COVER SHEET
SANITARY SEWER PLANS

WOODSIDE RIDGE
FIRST PLAT

LEE'S SUMMIT, MO

AS BUILT
Date Surveyed: 04-20-2020

SHEET
C213

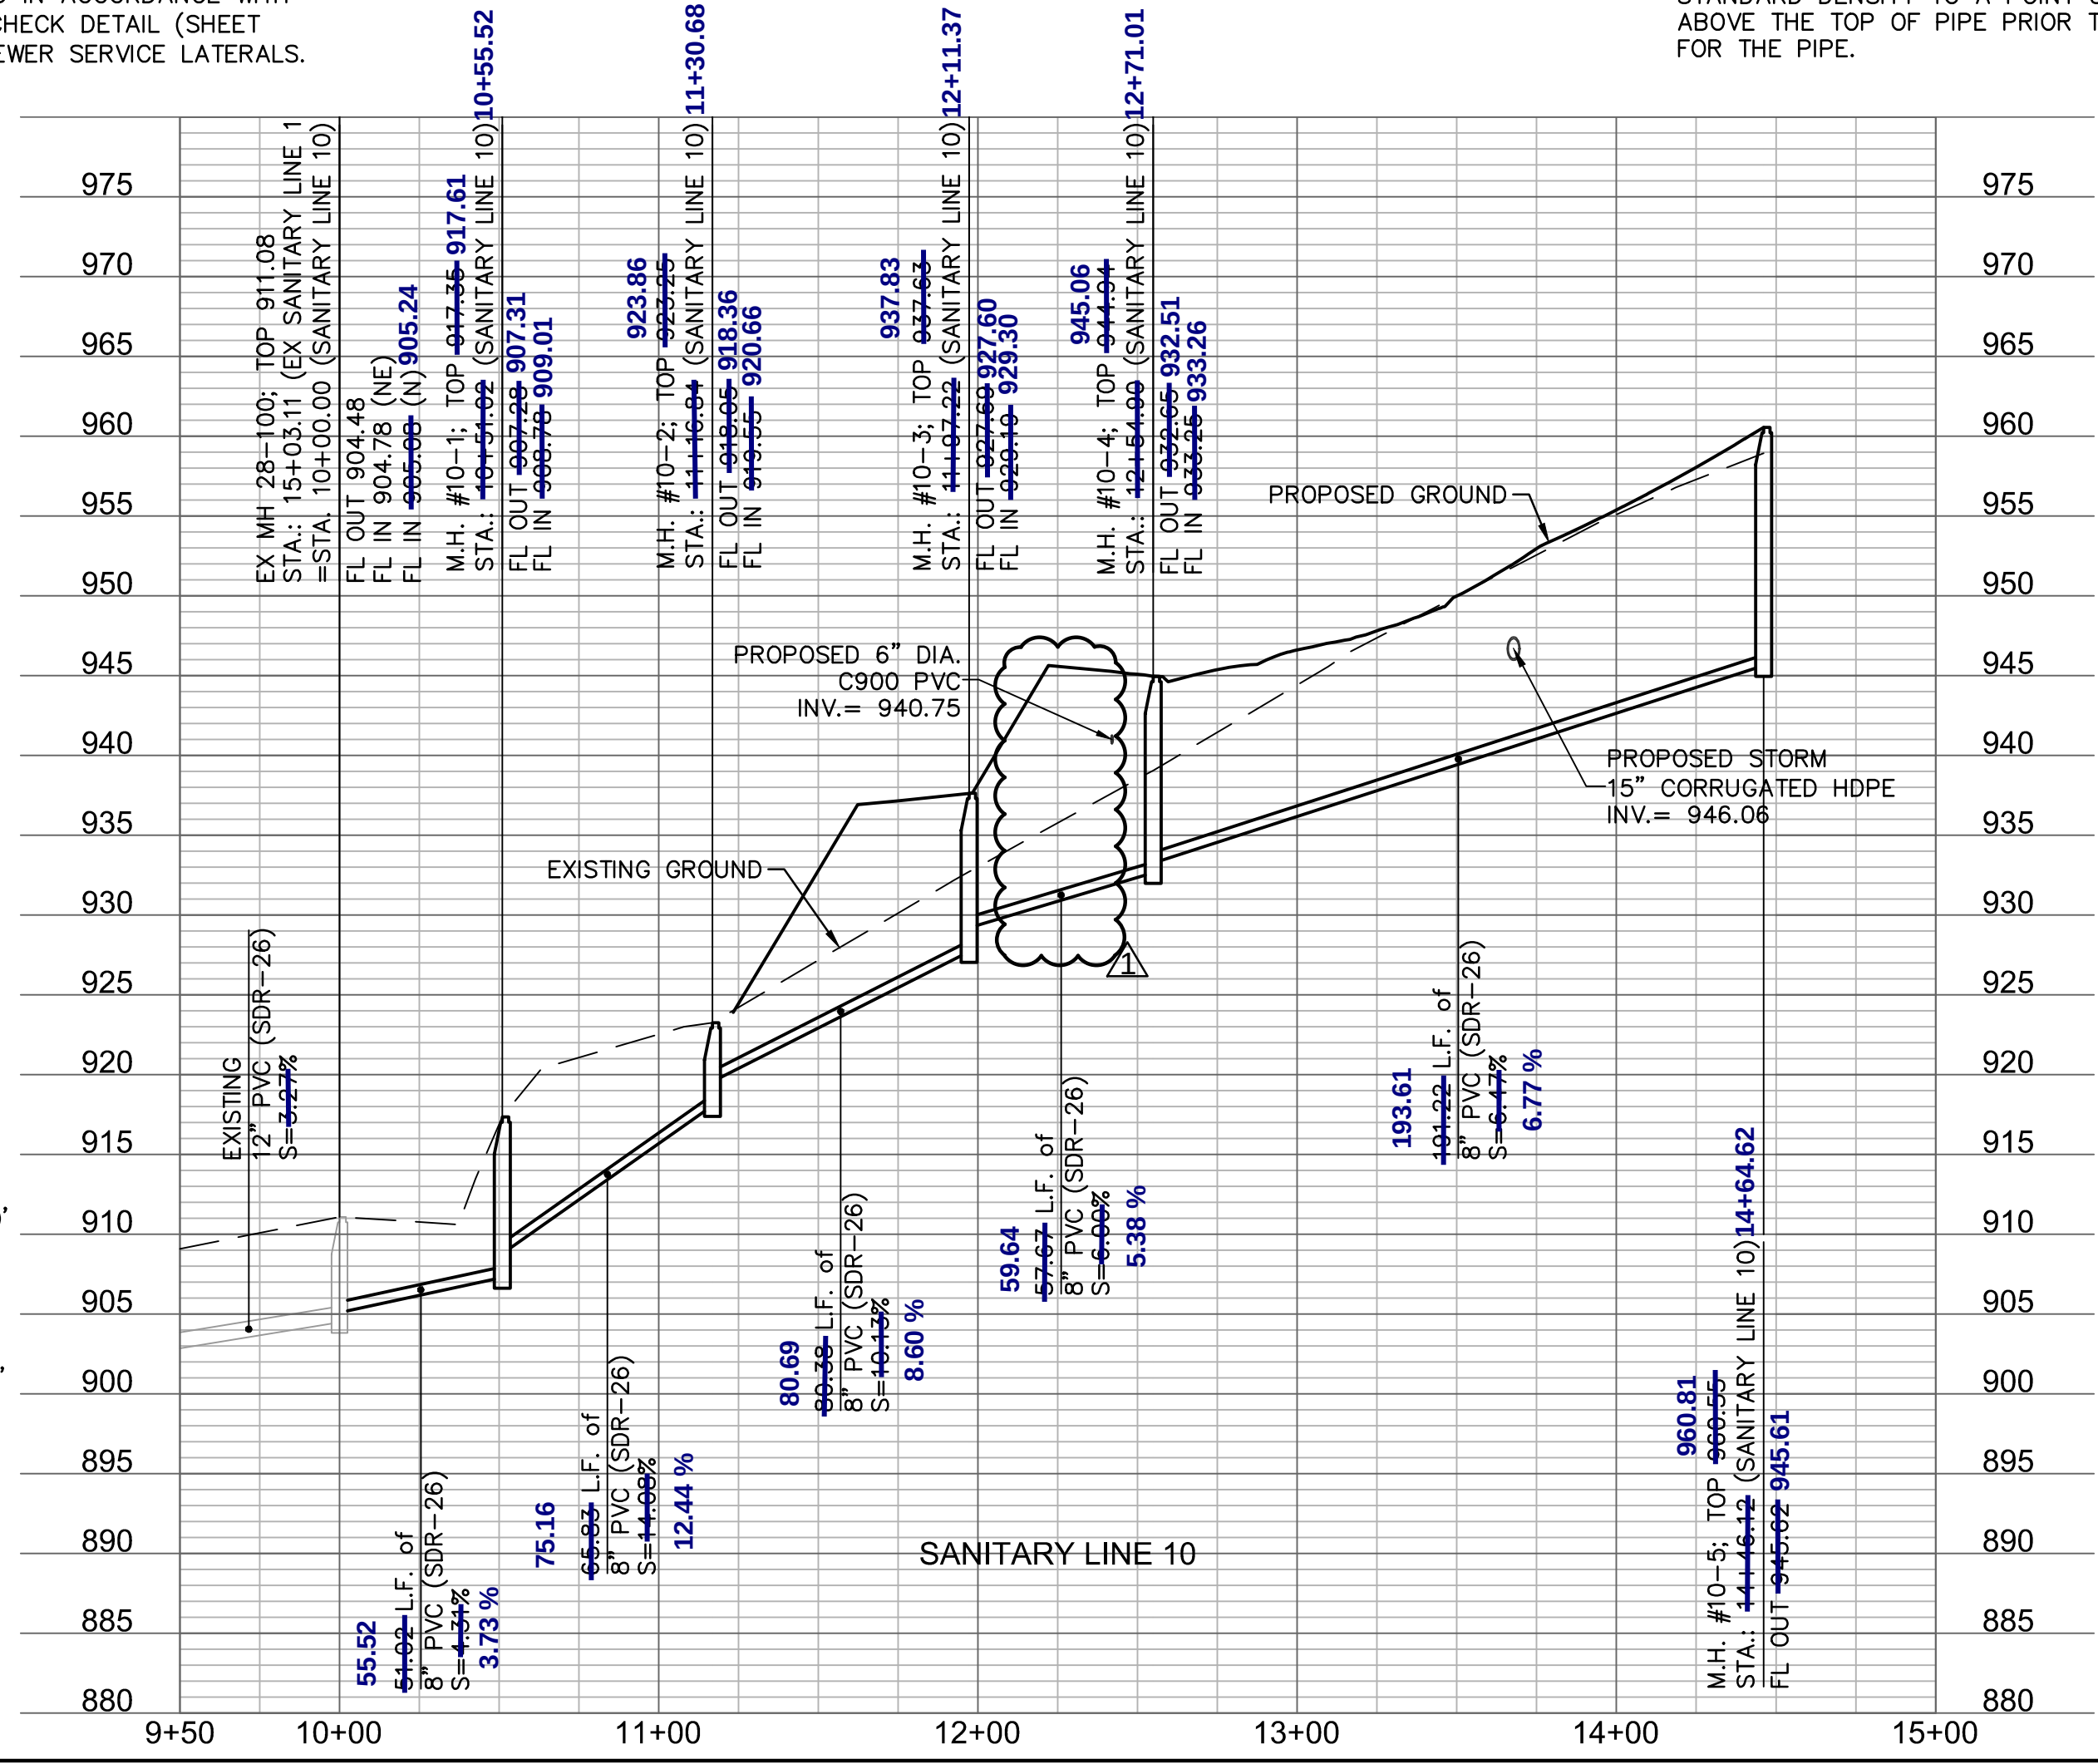
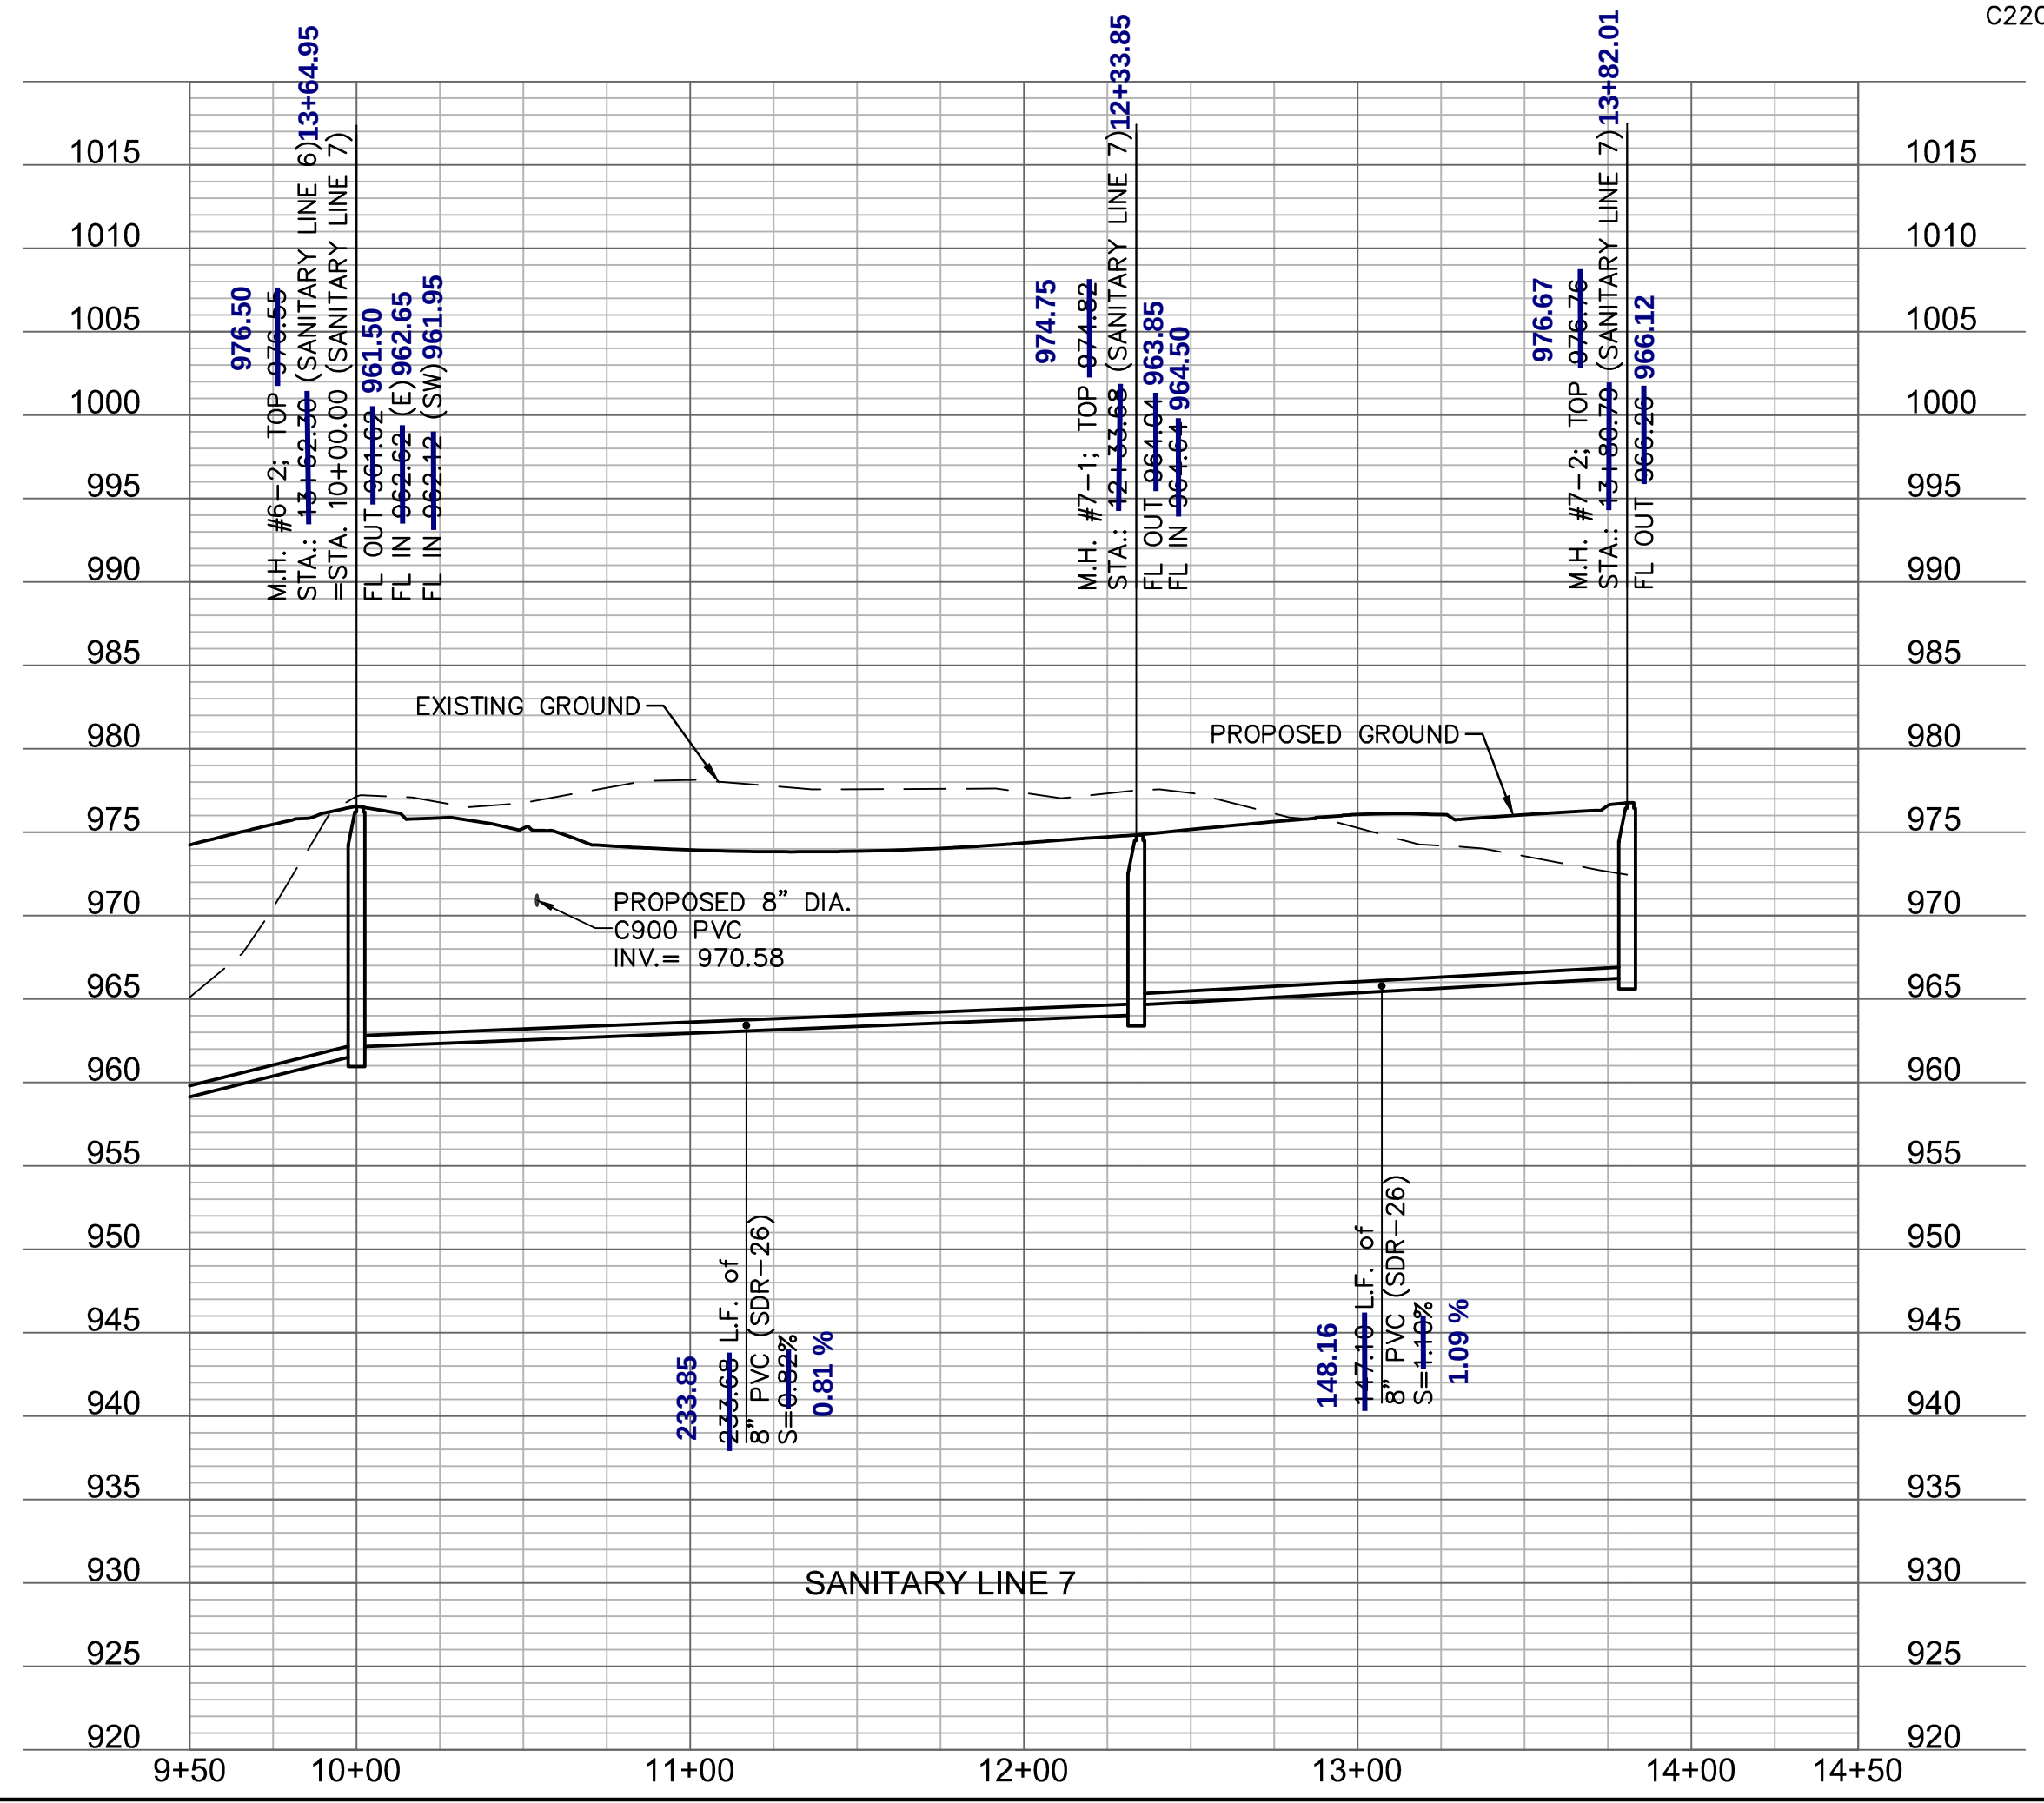
As-built is 0.56' S and
1.90' W of plan
M.H. #10-3, CONST. STD.
SANITARY MANHOLE (4' DIA. INSIDE)
STA.: ~~11+97.22~~ (SANITARY LINE 10)
=STA.: ~~10+63.37~~ (C) ~~10+62.72~~
NW KAYLEA COURT, ~~5.01'~~ RT ~~4.04'~~

As-built is 0.65' N and
1.18' E of plan
M.H. #10-4, CONST. STD.
SANITARY MANHOLE (4' DIA. INSIDE)
STA.: ~~12+54.90~~ (SANITARY LINE 10)
=STA.: ~~11+19.97~~ (C) ~~11+20.67~~
NW KAYLEA COURT, ~~16.06'~~ RT ~~18.11'~~

As-built is 3.02' N and
1.42' E of plan
M.H. #10-5, CONST. STD.
SANITARY MANHOLE (4' DIA. INSIDE)
STA.: ~~11+46.12~~ (SANITARY LINE 10)
=STA.: ~~13+10.90~~ (C) ~~13+13.98~~
NW KAYLEA COURT, ~~27.55'~~ RT ~~28.84'~~

As-built is 3.95' N and
0.50' W of plan
M.H. #10-1, CONST. STD.
SANITARY MANHOLE (4' DIA. INSIDE)
STA.: ~~10+51.92~~ (SANITARY LINE 10)
N: ~~1,003,081.4947~~ ~~1003085.45'~~
E: ~~2,812,310.1740~~ ~~2812309.68'~~
